Joint Planning Application Response

Local Authority:	High Peak
Detail:	Land at Dinting Vale, Glossop – Proposed residential development comprising 100 dwellings including areas of public open space, landscaping and associated works
Planning Ref:	HPK/2022/0456
Link:	http://planning.highpeak.gov.uk/portal/servlets/ApplicationSearchServlet?PKID=257670
Deadline:	7 th December 2022
Submitted by	Trans Pennine Trail National Office & Sustrans

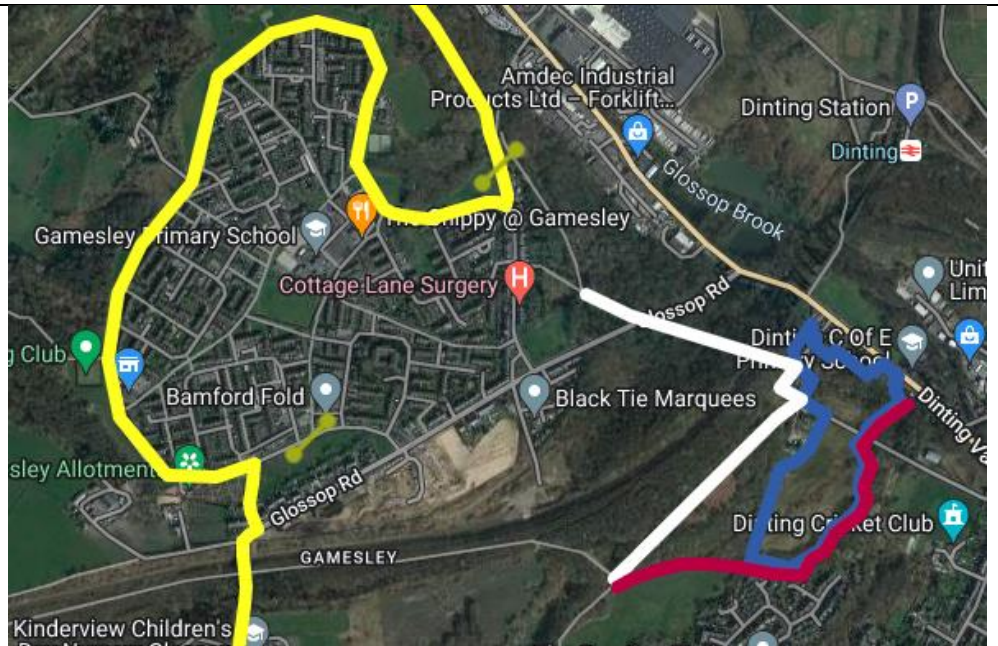
Whilst this development is not located directly on the Trans Pennine Trail or National Cycle Network it has been discussed previously as a future development that would enable enhancements to connections to the Pennine Bridleway and TPT/NCN network.

The pink route on the map above shows the potential route that could be delivered as part of this planning application. The current application indicates the provision of a walking route only from the north of the site down the eastern side, to the southerly point of the development. The Trans Pennine Trail and Sustrans ask that this walking route be upgraded to include cyclists as a minimum requirement and that equestrian provision is also considered. It is also requested that this provision be extended to meet the connecting bridleway as indicated. This would provide residents with direct access to the sustainable transport infrastructure already in place, without finishing abruptly at the southern end of the development with no onward connection.

It should also be noted that the white line shows an aspiration that was tabled some time ago to provide a connection for the Pennine Bridleway. Whilst it is agreed that this route requires major engineering works with no quick resolution, it is noted here as reference as the long-awaited link under the Arches to Cottage Lane.
